UNITED STATES
NUCLEAR REGULATORY COMMISSION
WASHINGTON, D.C. 20555-0001

FAILURE TIME EVALUATION

Figure 24 Variation of time to failure as a function of initial crack length, for the base case of 318°C, 95/50, crack growth rate.

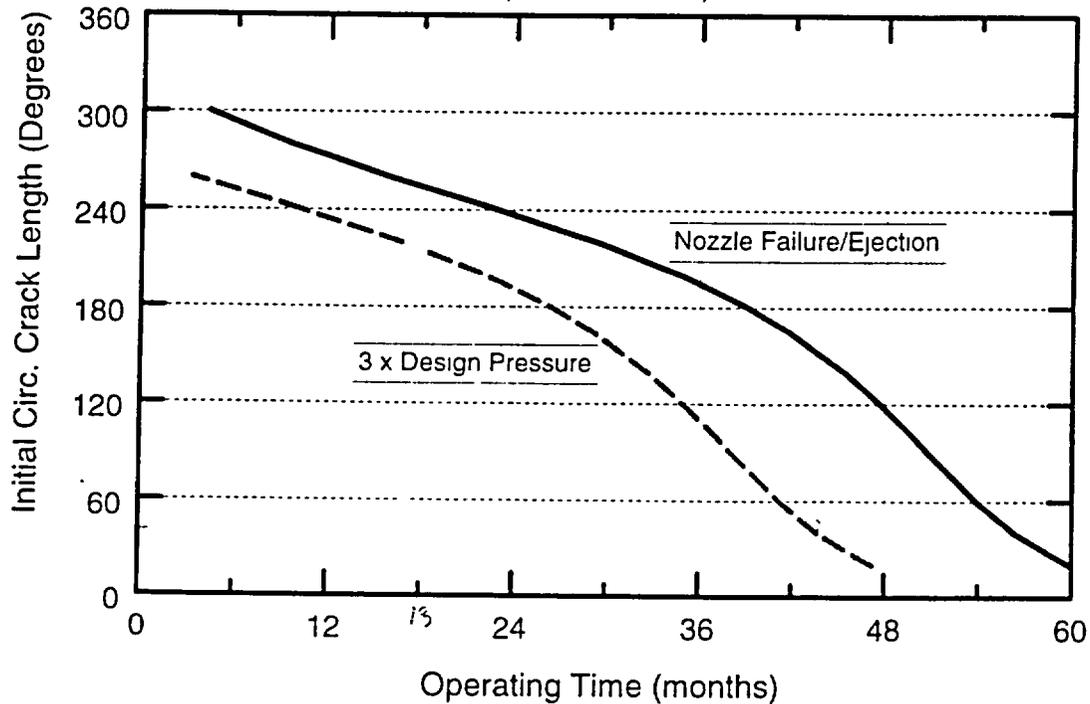
no credit for pictures
1996 — 94% inspected

no credit for 28 inspections from
1998 — 72% pictures

2000 — 65%
no credit for
meaningful inspection from pictures

1996 : 5 3/4 yrs = 69 months

Conclusion - there should
have been a failure by
now.

1998: 3 3/4 yrs = 45 months

23% Uninspected.
Original crack length - 450
to get to 3x in 45
months

2000: 19 months
35% uninspected, Original flaw size - 21
to get to 3x in 19 months
